T-DESIGN KNITWEAR LIMITED

13th August 2017

Observations

Observation: Utility Building

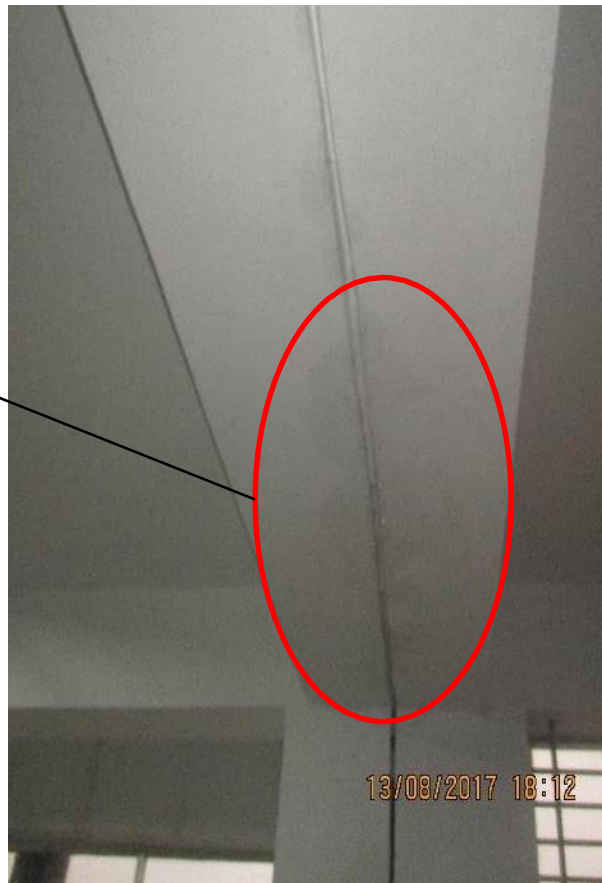
Factory Engineer prepared a load plan considering 5 Kpa (100 psf) allowable floor loading for Utility building. Design review required if the factory management wants to implement that load plan.

Factory is required to maintain floor live load 3Kpa until further verification by design engineer. During inspection, no overloading was observed and FOS calculation for internal column was found satisfactory considering 3Kpa allowable live loading.

- Maintain 3 Kpa loads on all floors.
- Produce and actively manage a load plan for all floor plates within the factory giving consideration to floor capacity and column capacity if loading above 3Kpa is considered.
